RESPONSE TO DOUGLAS SHIRE COUNCIL INFORMATION REQUEST: S.13 OF THE DEVELOPMENT ASSESSMENT RULES

DEVELOPMENT APPLICATION OVER LAND AT CAPTAIN COOK HIGHWAY, CRAIGLIE (LOT 2 ON SR431) SEEKING A DEVELOPMENT PERMIT FOR RECONFIGURING A LOT (ONE (1) LOT INTO THIRTY-FOUR (34) RESIDENTIAL LOTS, NEW ROAD AND BALANCE LAND)

COUNCIL REFERENCE: ROL 2021_4012/1

Figure 4-2 SIDRA assessed layout - Captain Cook Highway / Milman Drive Intersection - reconfigured

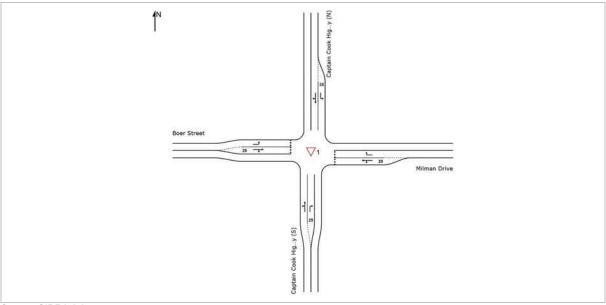
The intersection analysis for the Captain Cook Highway/Milman Drive intersection is to be undertaken in an approved modelling package (SIDRA or equivalent). All upgrades identified in the Road Safety Audit or the intersection analysis will need to be identified in engineering design plans and associated reports.

It is recommended that the turn treatments indicated in the reconfigured intersection form (Figure 4-2) are incorporated into the layout regardless of the intersection operation, to improve the overall safety at this location.

MASTER PLAN

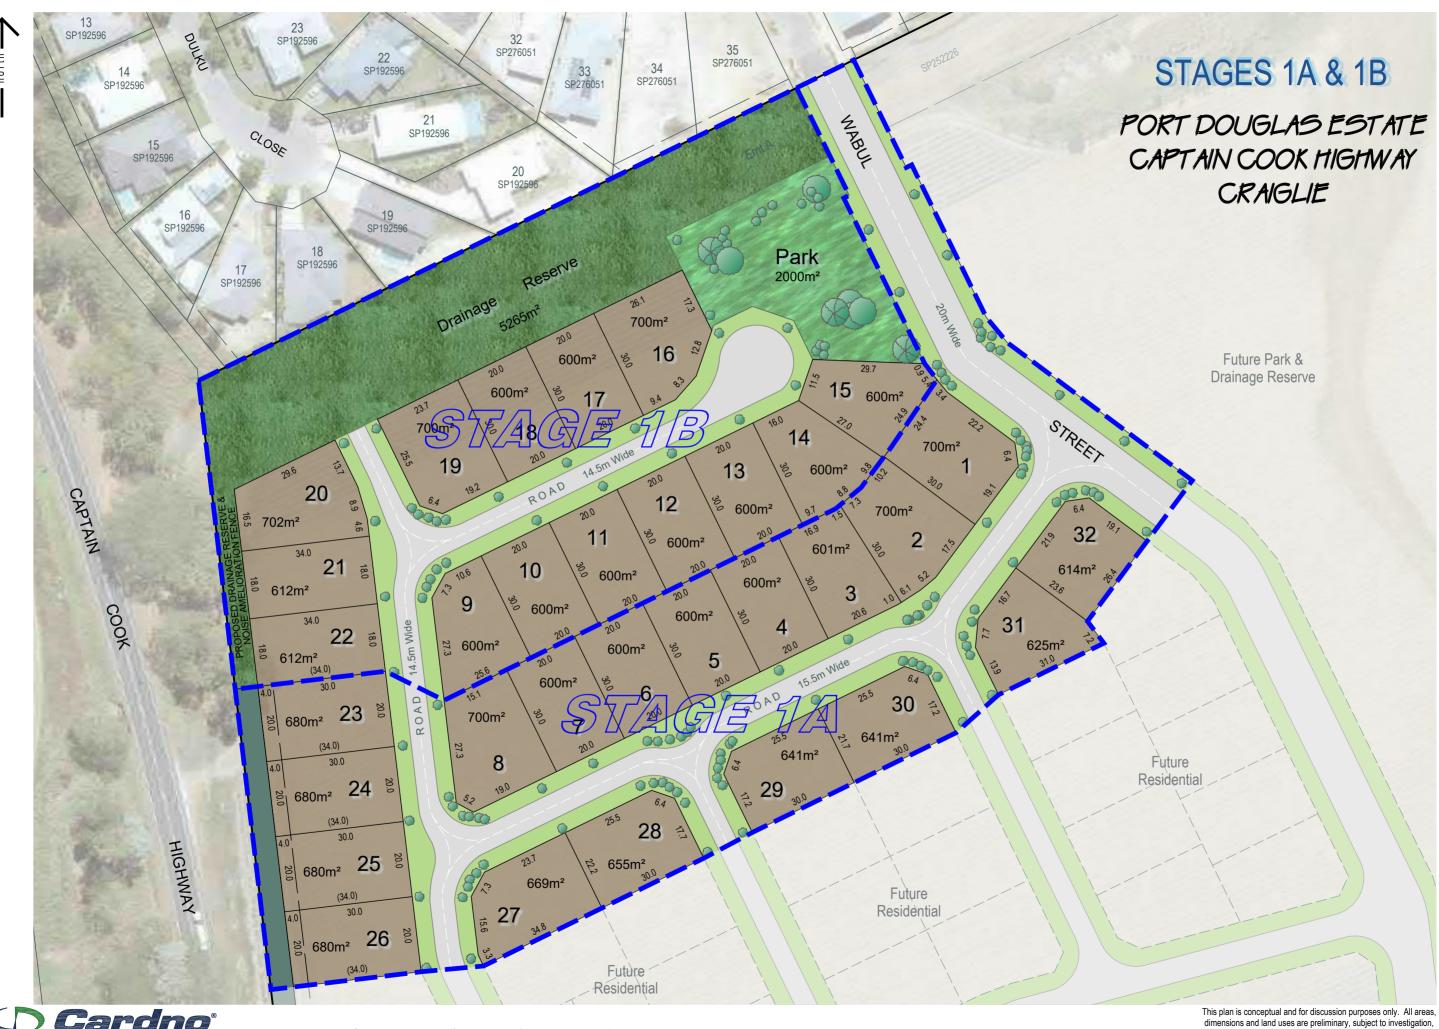
1. Please provide a masterplan for the whole of the land and any other land intended to form part of the residential development of this area held by the applicant. The masterplan is to include an indicative lot layout, stages, road network, park and drainage lots.

The masterplan is to indicate proposed infrastructure. Please provide comments in response to A08 and PO8 of the Reconfiguring of a Lot Code and the respective overlay codes.

As stated within the submitted Town Planning Report, a Master Plan was provided to Council as part of the Stage 1 Reconfiguring a Lot Development Application, and attached to Council's Decision Notice (ROL 2966/2018 – page 3), dated 28 May 2019. The Stage 1 ROL approval is referenced in the submitted DA Form 1 as an associated development approval. The Master Plan was also provided to Council as part of and in support of the Stage 1 Operational Works Development Application (OP 2019_3370/1).

The master planning exercise undertaken as part of Stage 1 provides guidance and a preliminary layout and design of the estate. Proposed Stage 2 presents a logical expansion of the estate, the proposed lot layout and design being pre-determined by the road reserves approved and constructed under Stage 1.

A copy of the Master Plan (Preliminary) provided to Council as part of Stage 1 development is provided at Attachment B and a Master Plan (Preliminary) with indicative staging is provided at Attachment C. However, it must be noted that these Master Plan documents are preliminary only for the purpose of guiding potential future planning outcomes for the site. Future development of the balance land (Lot 2 on SR431) may be subject to changes during further planning and detailed design.
